UNITED STATES  
DEPARTMENT OF THE INTERIOR  
BUREAU OF LAND MANAGEMENT

**SUNDRY NOTICES AND REPORTS**  
*Do not use this form for proposals to drill or to re-enter an abandoned well. Use form 3160-4 for such proposals.*

5. Lease Serial No. NMNM05792
6. If Indian, Allottee or Tribe Name
7. If Unit or CA/Agreement, Name and/or No.
8. Well Name and No. ROJO 7811 34-27 FEDERAL COM 21H
9. API Well No. 30-025-44300-00-X1
10. Field and Pool or Exploratory Area WC025G09S253336D-UPPER WC
11. County or Parish, State LEA COUNTY, NM

BTA OIL PRODUCERS, LLC RESPECTFULLY REQUESTS A CHANGE TO THE ORIGINAL APD FOR THE SURFACE HOLE LOCATION.

**WELL LOCATION AND ACREAGE DEDICATION PLAT**

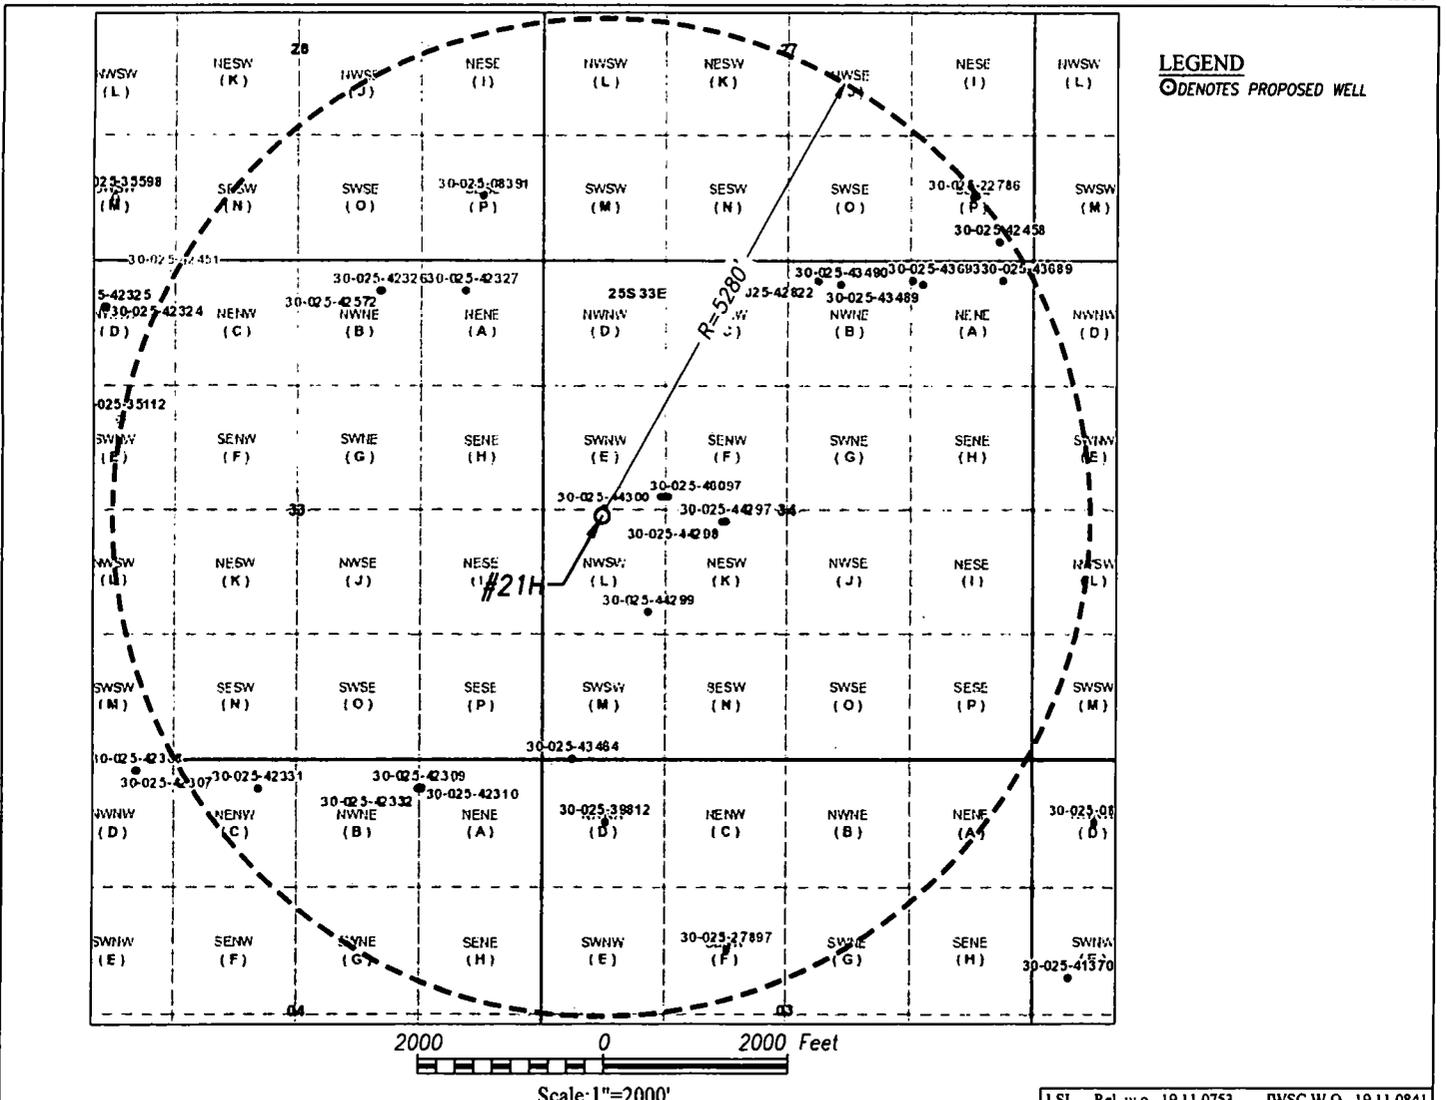
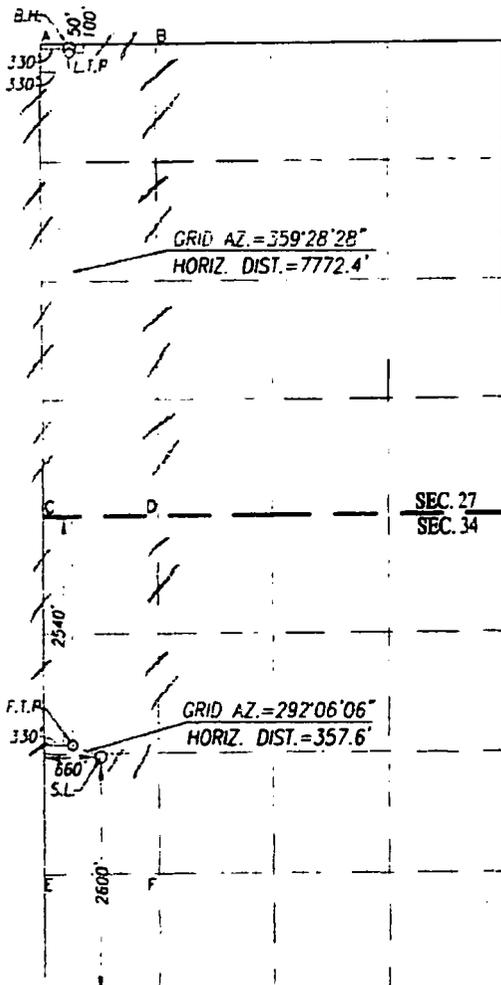
ORIGINAL SURFACE HOLE LOCATION: 1540 FSL; 660 FWL. LATITUDE 32.084000 ; LONG 103.566599

NEW SURFACE HOLE LOCATION: 2600 FSL; 660 FWL. LATITUDE 32.086913 ; LONG 103.566608

*Correct as map*
